# OVERLOOK AT HOMESTEAD FILING NO. 1

## FINAL PLAT

# V1\_Final Plat Drawings.pdf Markup Summary

DRAWN BY	JWT
CHECKED BY	ERF
H-SCALE	1" = 100'
JOB NO.	2422-00
DATE CREATED	06/05/24
DATE ISSUED	DRAFT
SHEET NO	2 OF 4

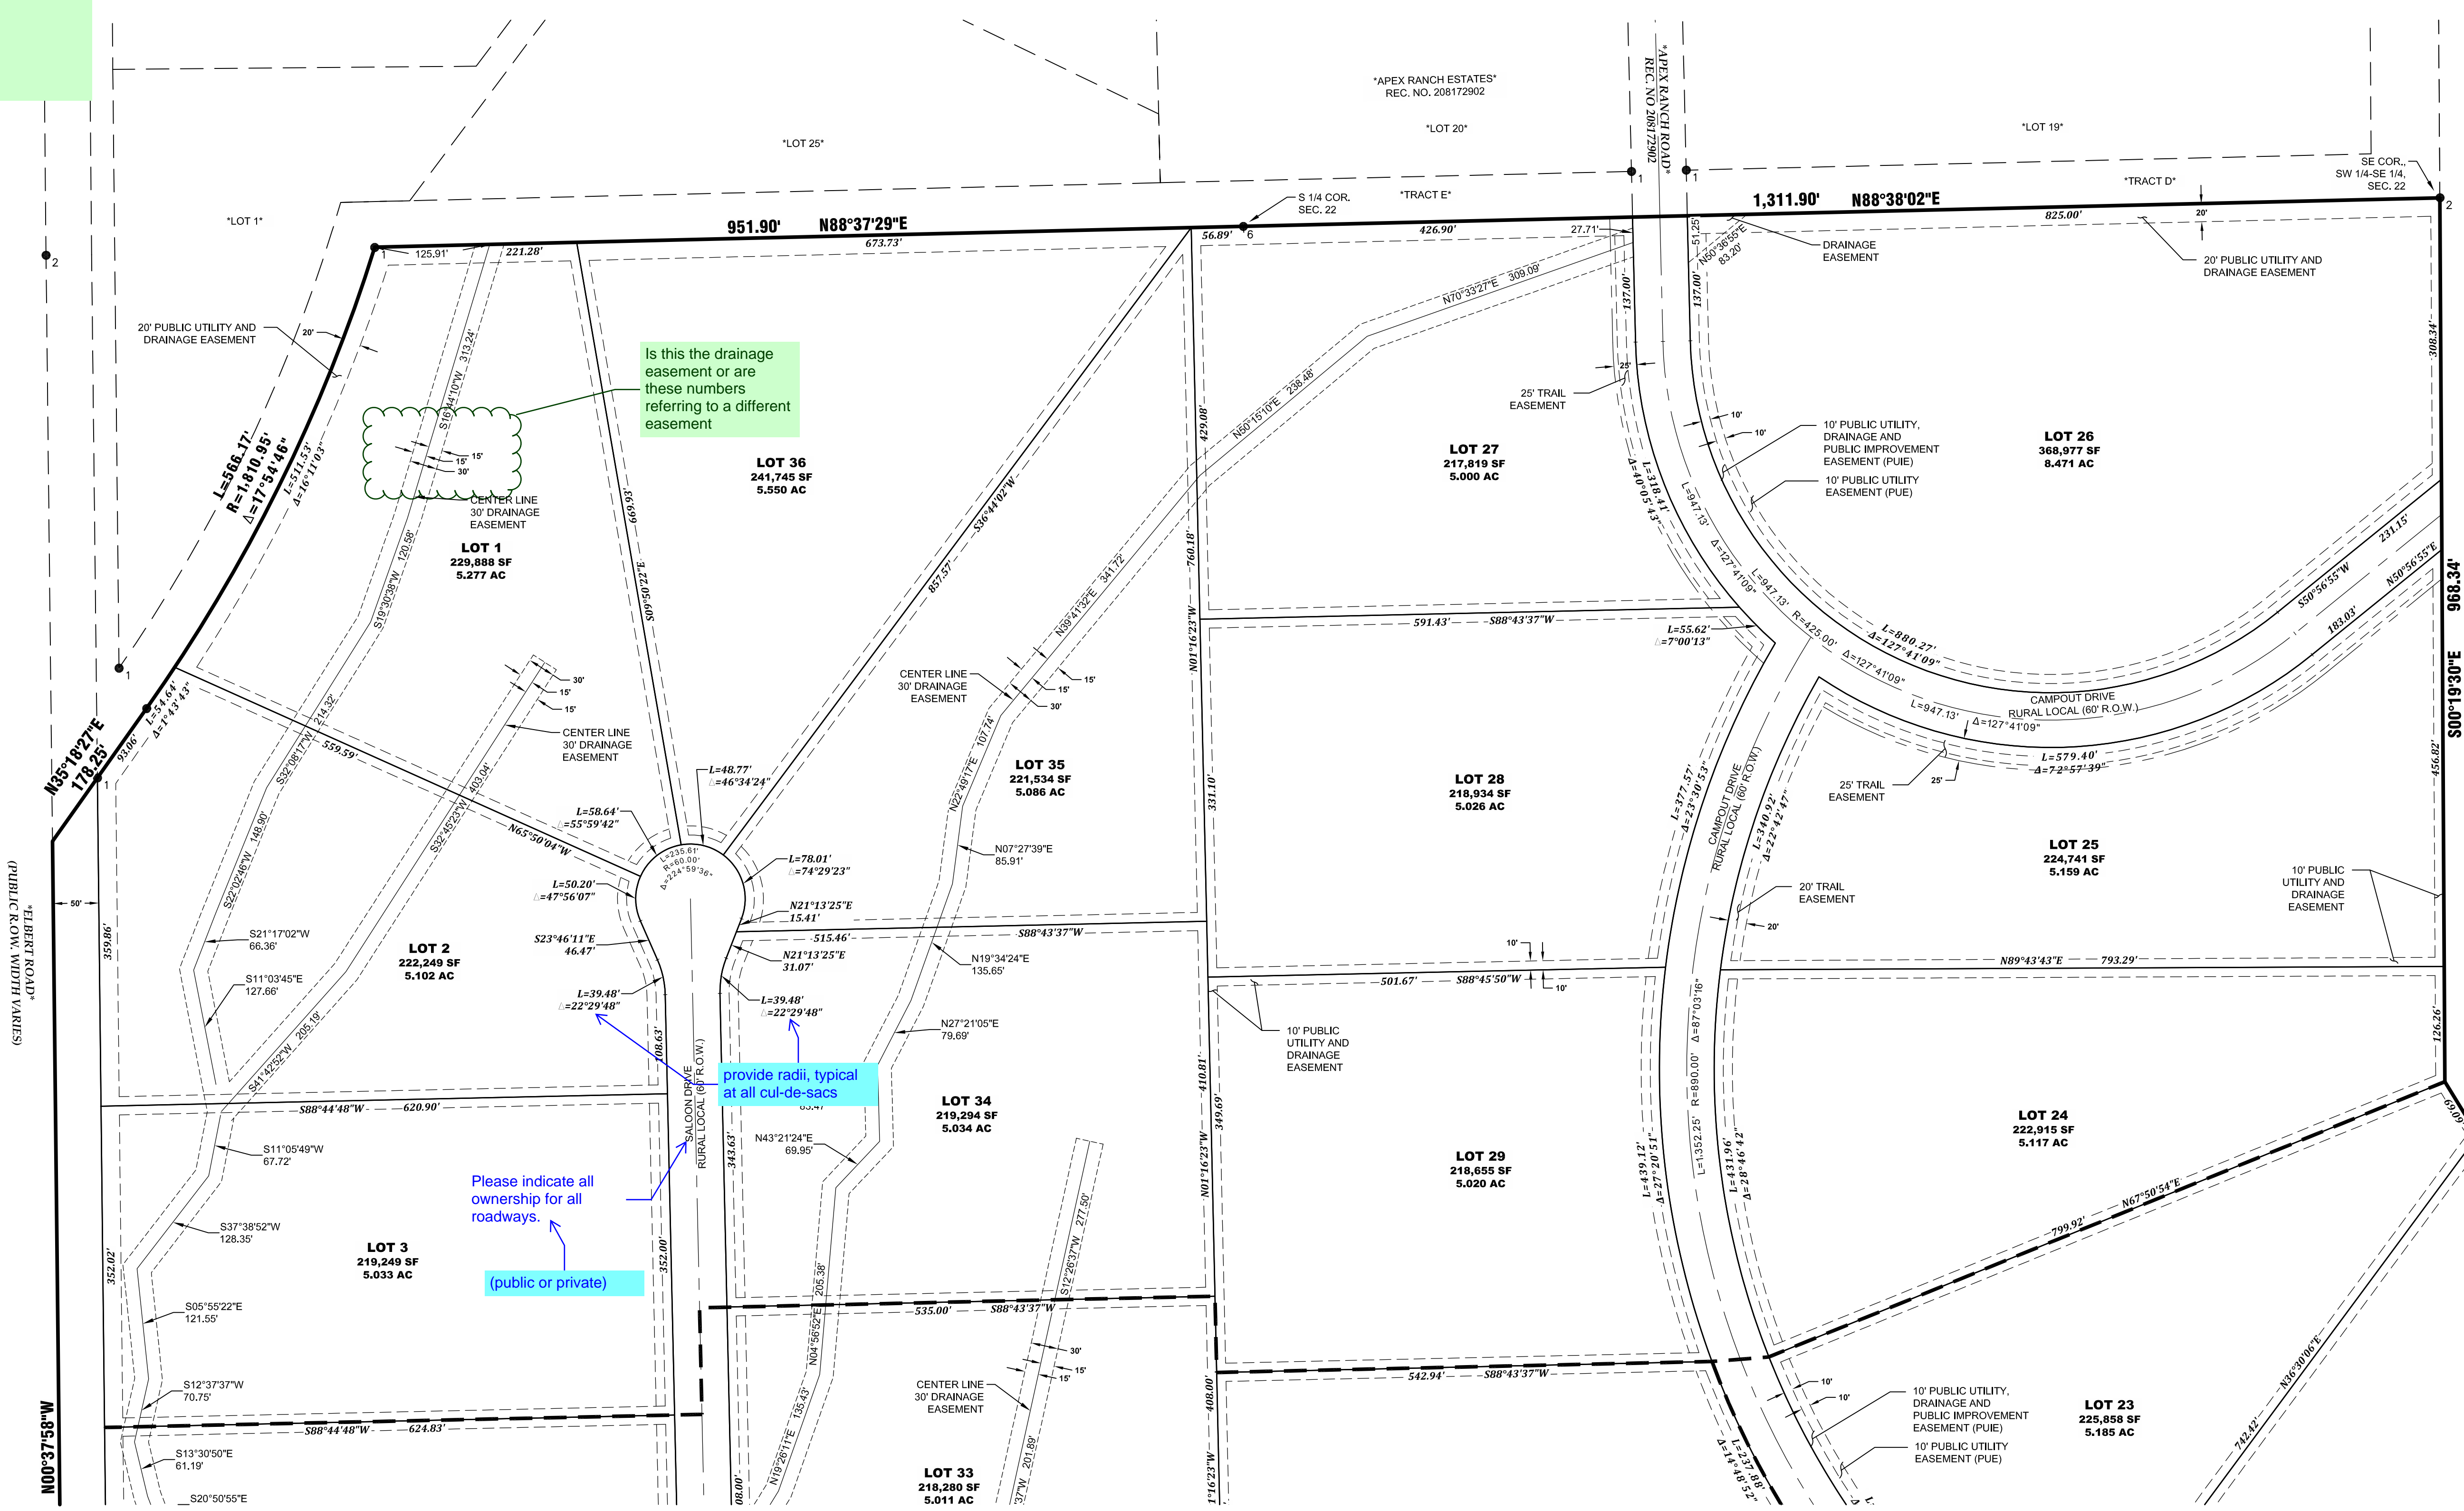
Include addresses from PPRBD

Please provide match lines

Please indicate all ownership for all roadways.

Include addresses from PPRBD

Is this the drainage easement or are these numbers referring to a different easement

Please provide match lines

(public or private)

provide radii, typical at all cul-de-sacs

DRAWN BY	JWT
CHECKED BY	ERF
H-SCALE	1" = 100'
JOB NO.	2422-00
DATE CREATED	06/05/24
DATE ISSUED	DRAFT
SHEET NO	3 OF 4

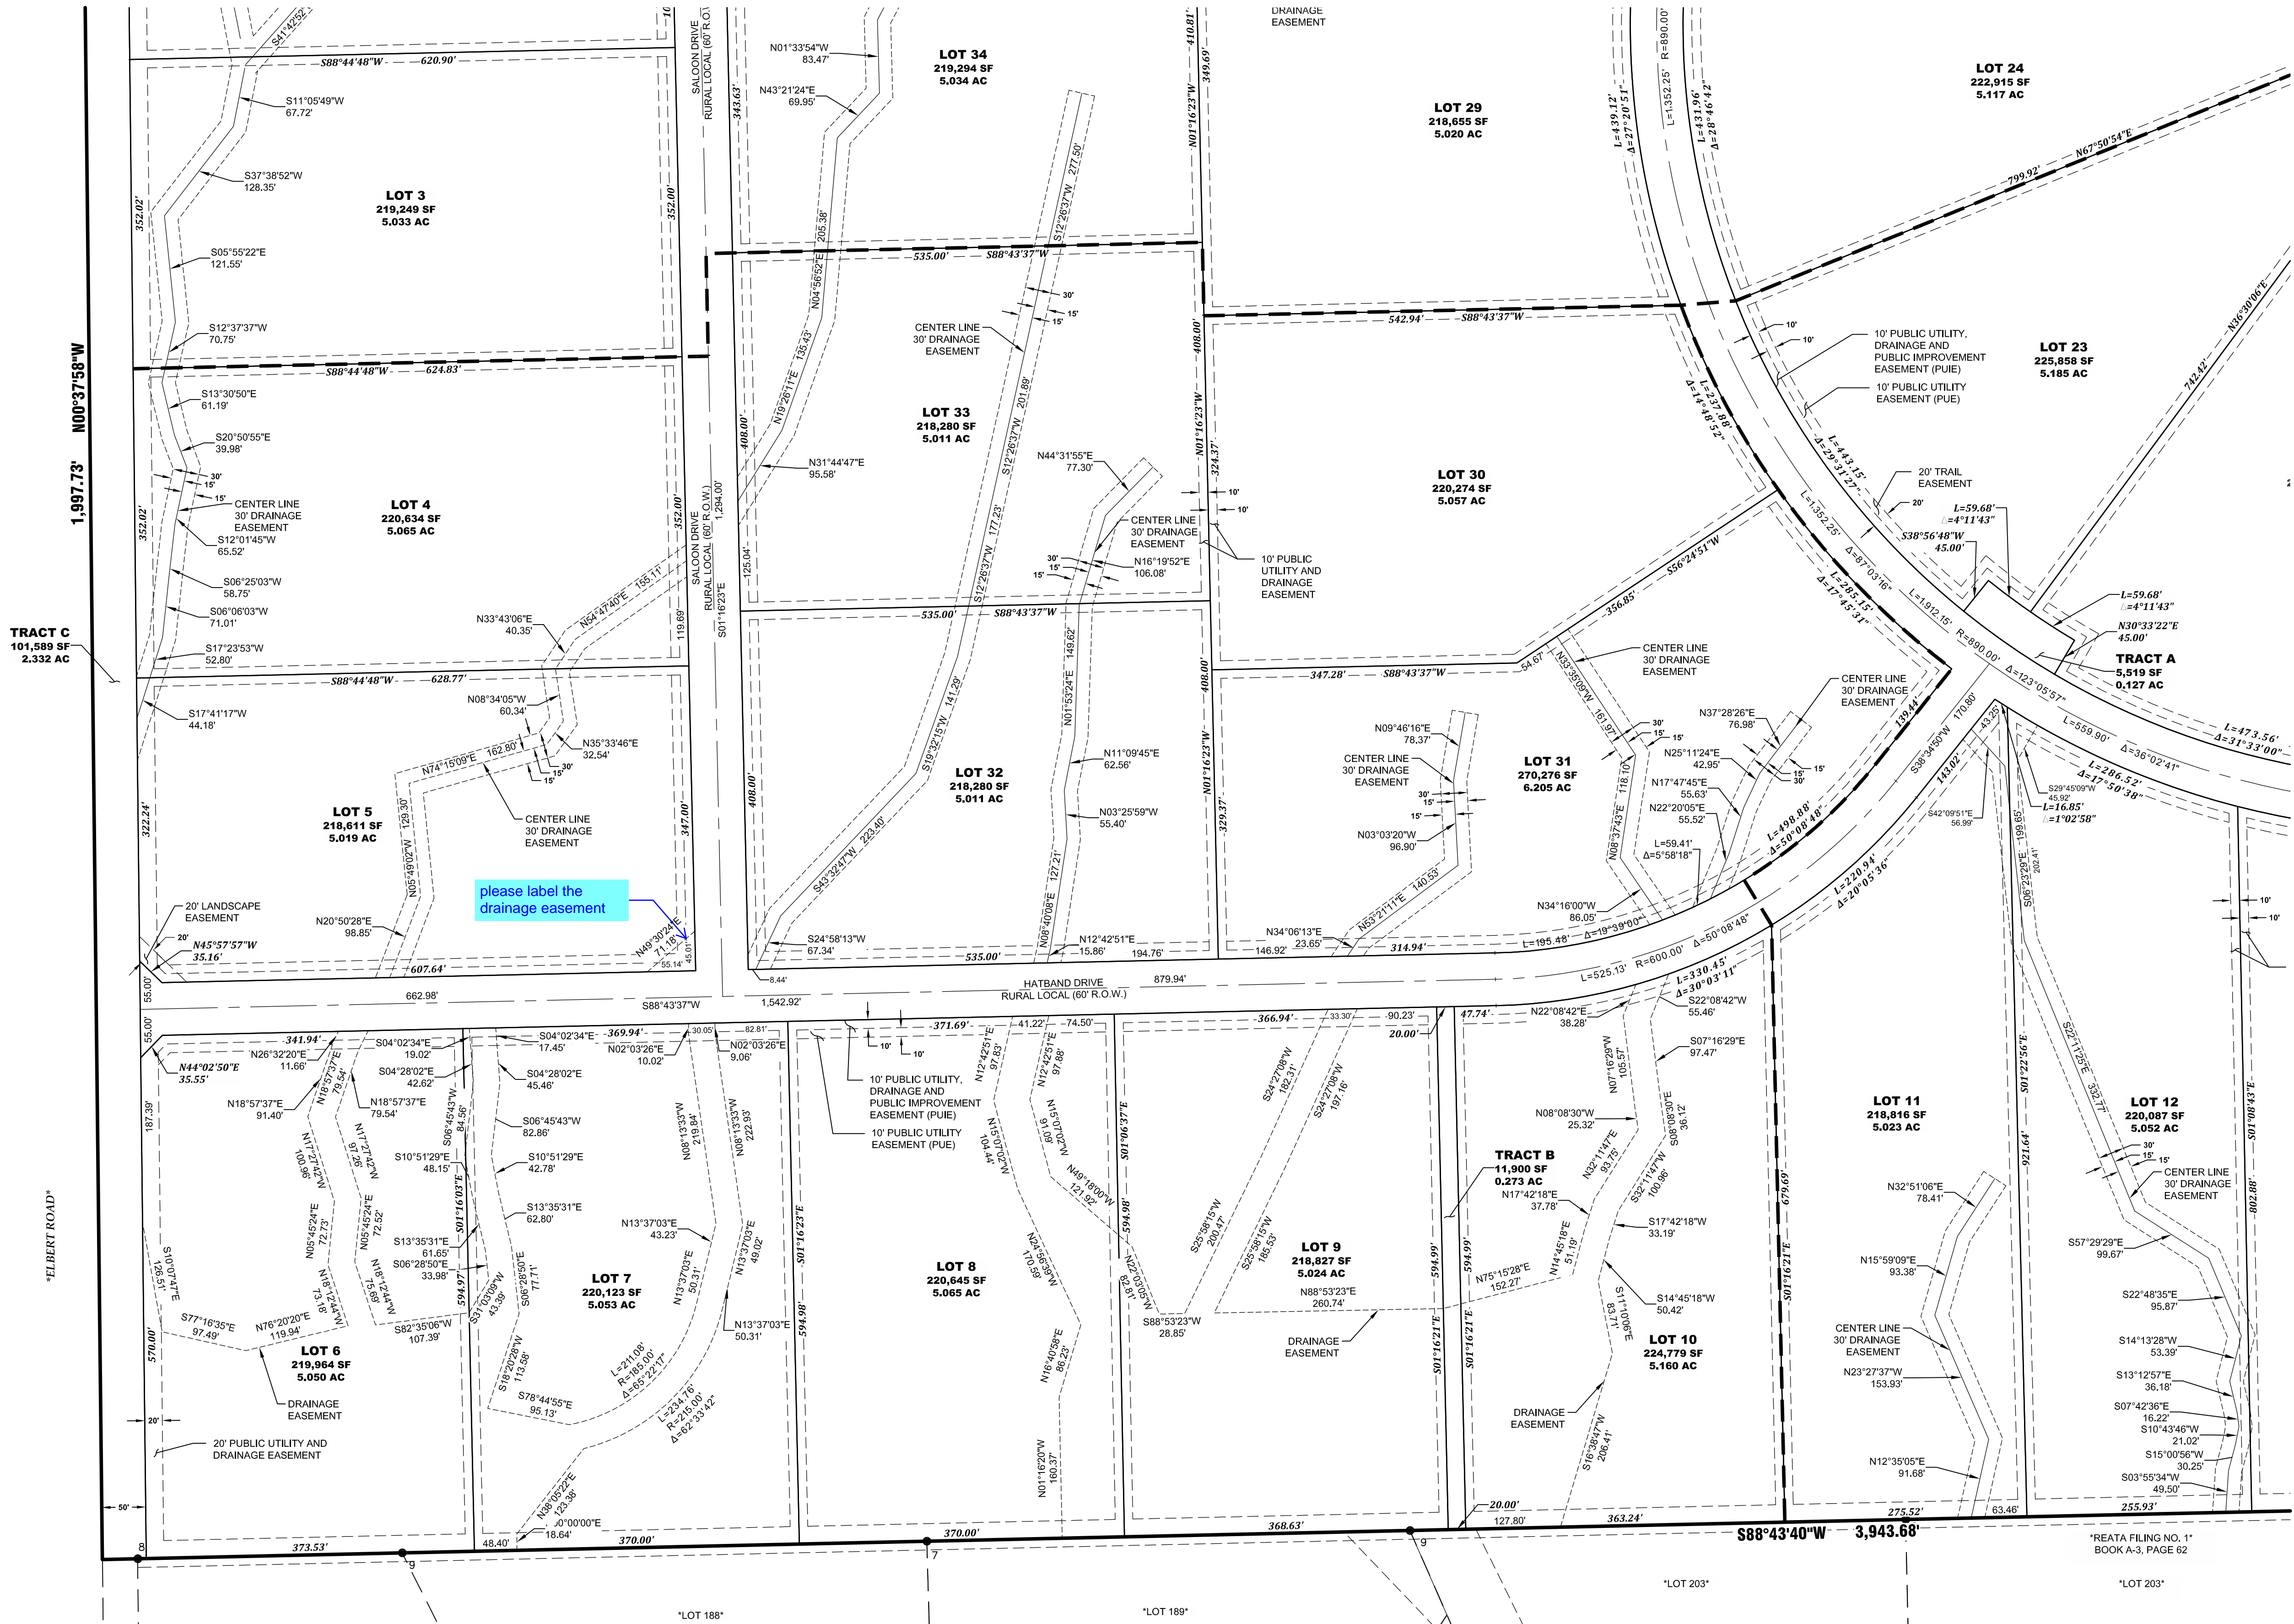
please label the drainage easement

DRAWN BY	JWT
CHECKED BY	ERF
H-SCALE	1" = 100'
JOB NO.	2422-00
DATE CREATED	06/05/24
DATE ISSUED	DRAFT
SHEET NO	4 OF 4

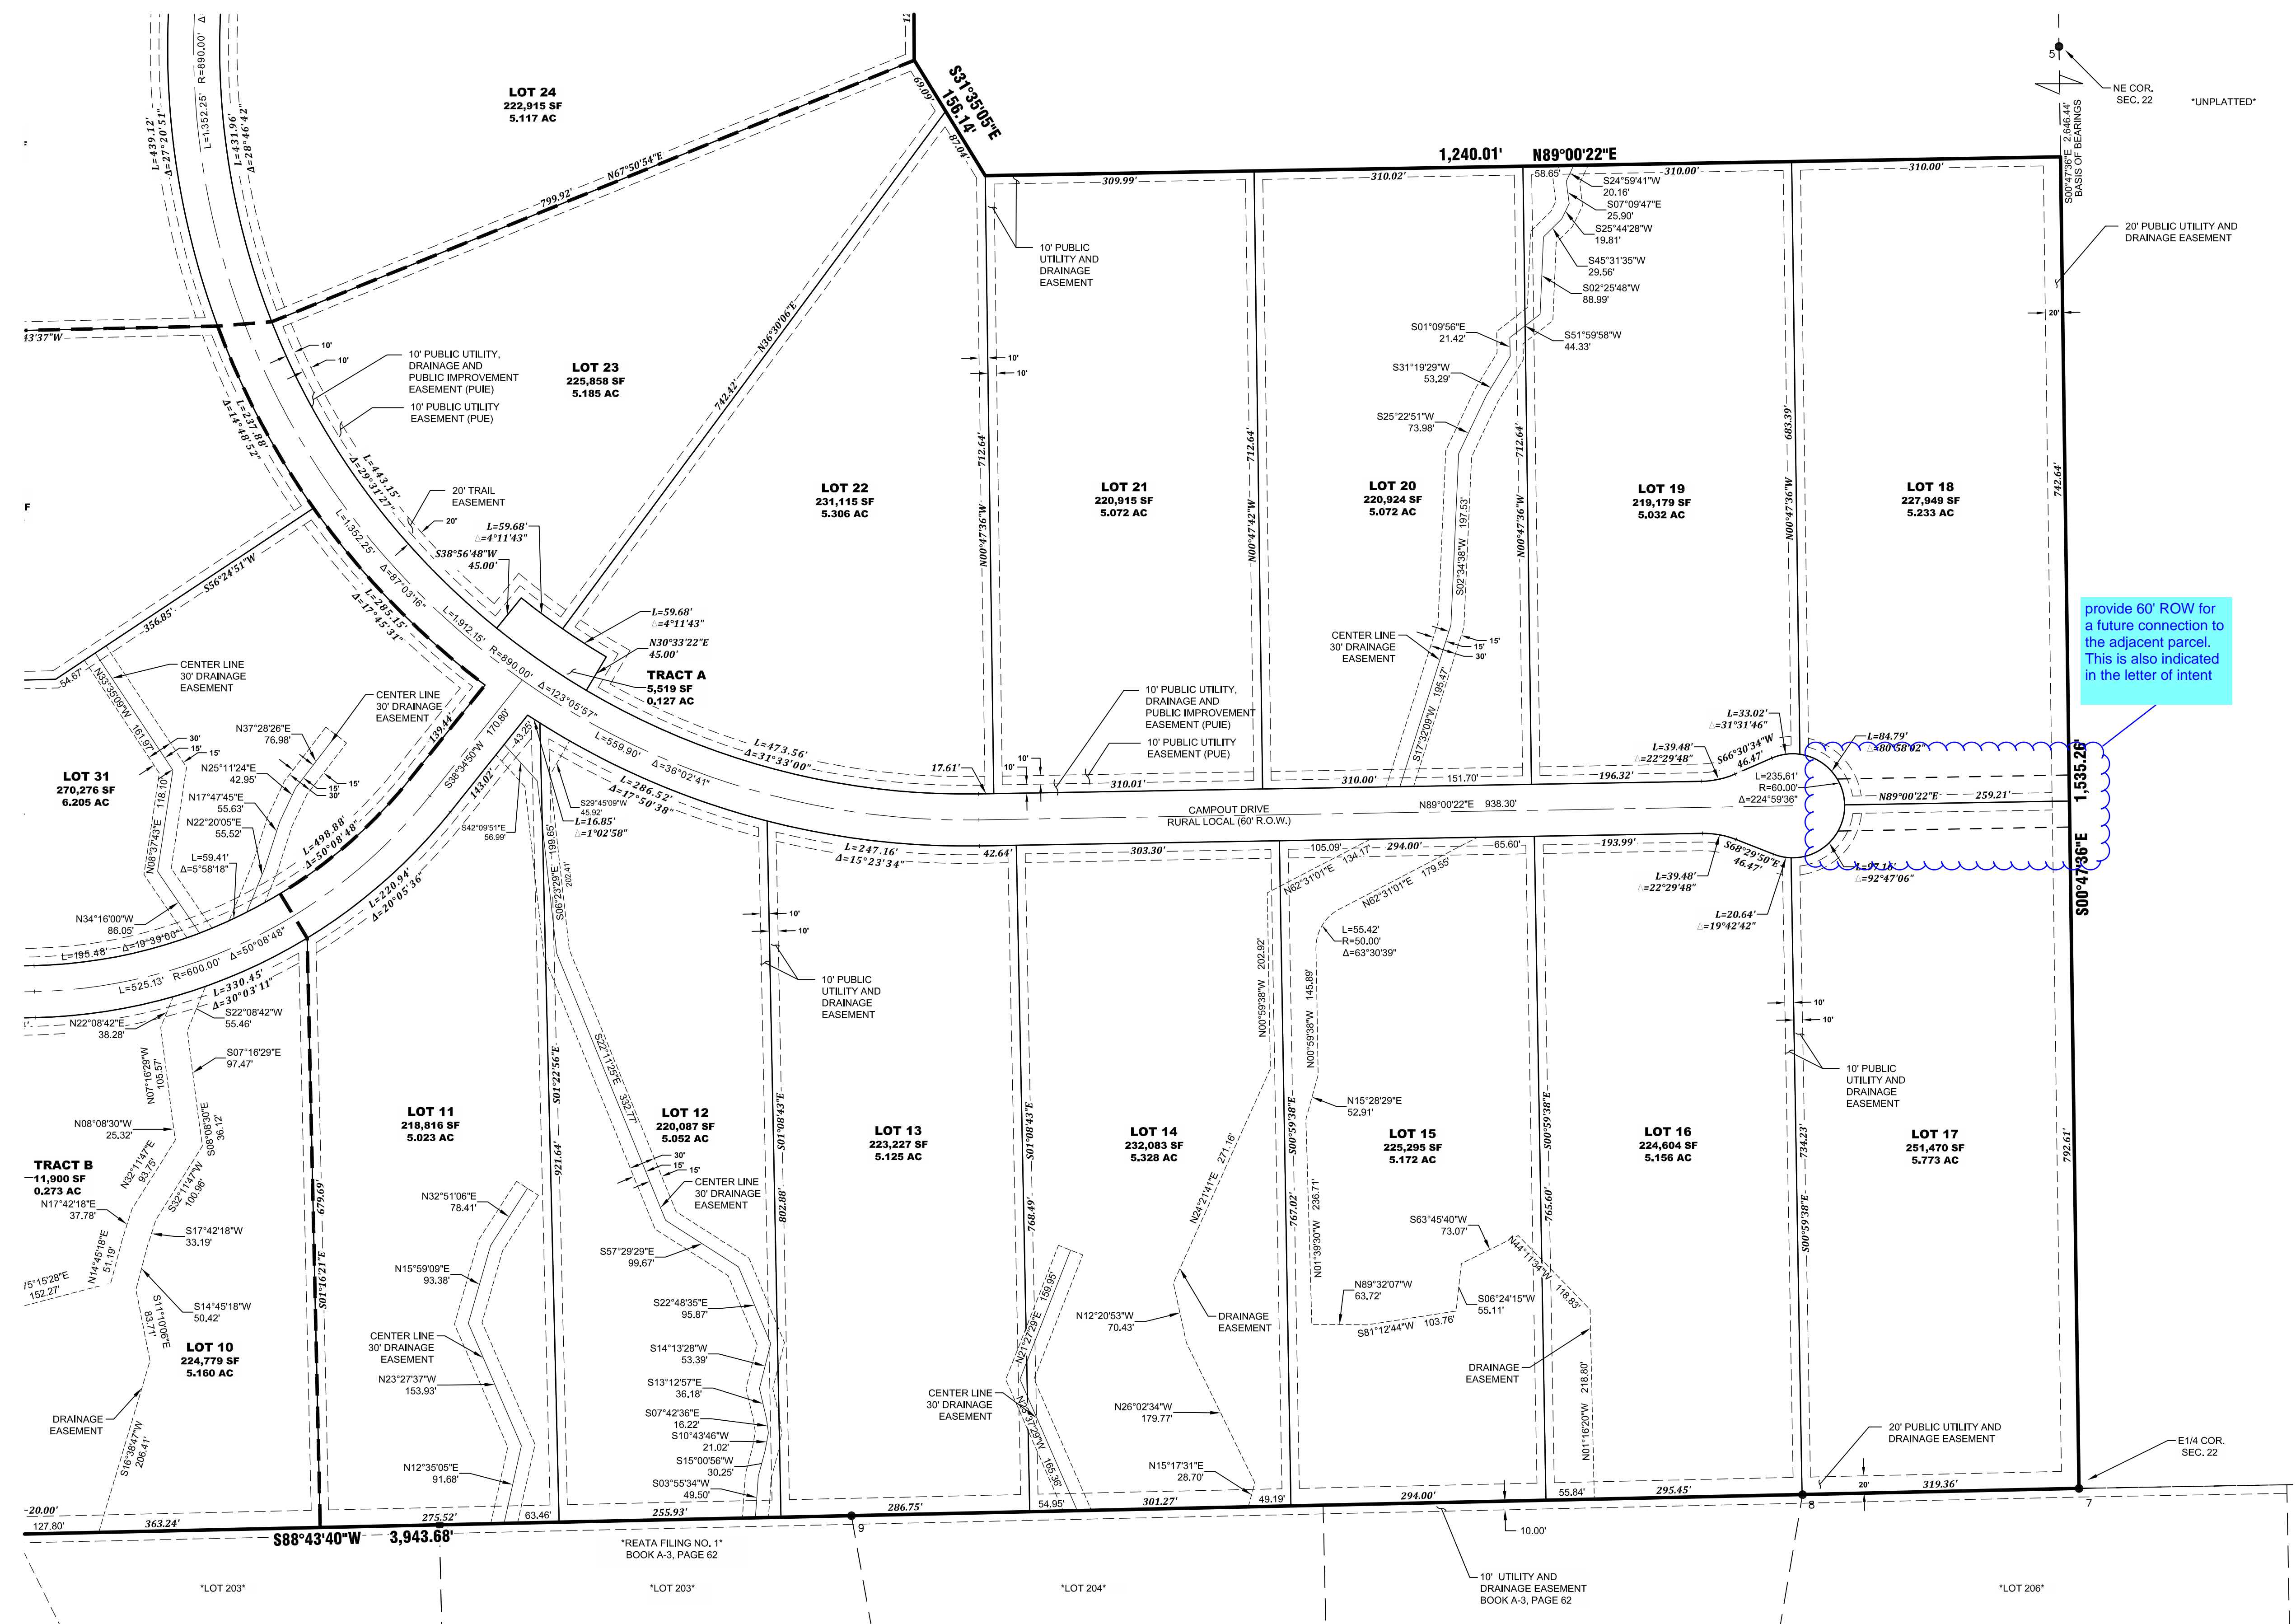
provide 60' ROW for a future connection to the adjacent parcel. This is also indicated in the letter of intent
